Service Note

Product	Description:	Service note no.
NovaSystem	Modification of distortion board due to beeps	Sno-T084

Picture 1

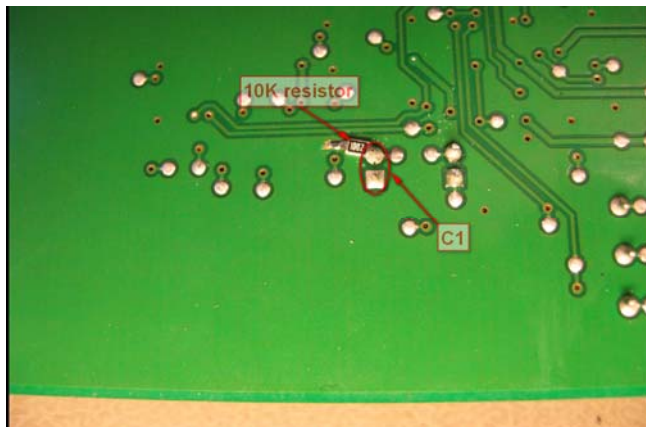
Unfortunately we discovered a fail that causes beeps in the output when using the distortion board.

1.	Add a 10K0 - 0805 SMD resistor (E15400101), from "C1" negative side to AGND plane. See Picture 1 & 2 Soldermask must be made open at resistor agnd side to solder.
2.	Rotate the "C4" Electrolytic 47uF/25V (E22002411) See Picture 3. (Electrolytic "-" side must point at silkscreen "+" side).
3.	Cut connection between C26 and "IC7" pin 8. See Picture 4
4.	Add 2pcs. 1n4148 diodes (E31001511) from "IC5" pin8 and pin9 to "IC7" pin8. See Picture 5
5.	Add a 10K0 – leaded resistor (E10501911) from "IC7" pin8 to DGND plane. See Picture 6
